# STAFF REPORT

## CONCERNING APPLICATION FOR A CERTIFICATE OF APPROPRIATENESS

**Application Number:** 2019-0329

**Property Location:** 1314 East Wayne Street

"Frame pulled away from house"

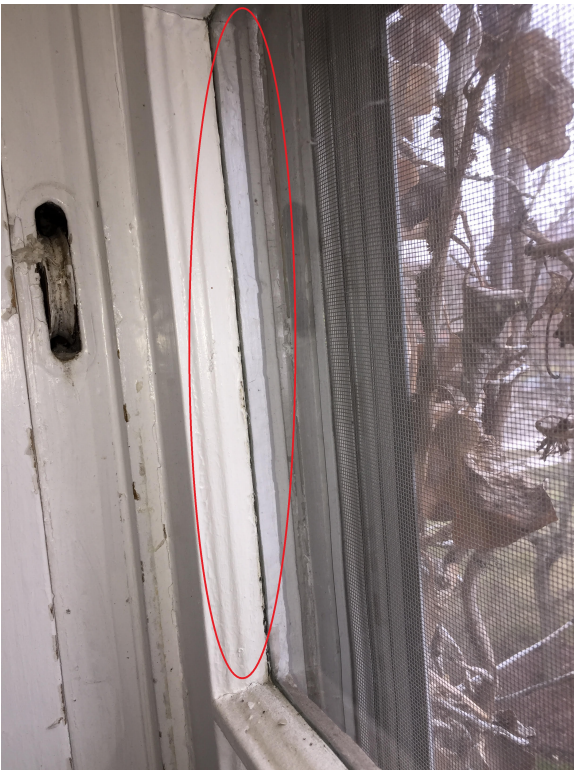
From photographs provided by the owner and Renewal by Anderson, staff acknowledges visible peeling paint on the wood storm windows on the first story, some broken sash cords, intermittent glazing failure, and layers of paint build up. No determination has been made as to if the windows are deteriorated beyond repair. Staff recommends that the owner engage a window restoration professional to determine the condition of the windows and the feasibility for repair.

**PRESERVATION INSPECTOR REPORT:** On March 19, 2019, I visited the property located at 1314 E Wayne N. The property owner has begun the COA application process to replace windows on the structure. I had not received a detail of which windows were part of the application, so I created an inventory of the entire structure. I was instructed to inspect from the outside only as the owner has many dogs and she would provide interior photos. Every window has a storm window in place. As a result, I am unable to make a determination on the condition of the windows in their current state. Several of the wood storms on the first floor appeared to be ajar or not closed tightly as the photographs will indicate.

**STAFF RECOMMENDATION:** Although the proposed windows resemble the original, without a determination that the original windows are deteriorated beyond repair or that a repair is not economically feasible, per the Standards for East Wayne Street Local Historic District, Staff does not offer a recommendation to the Commission.
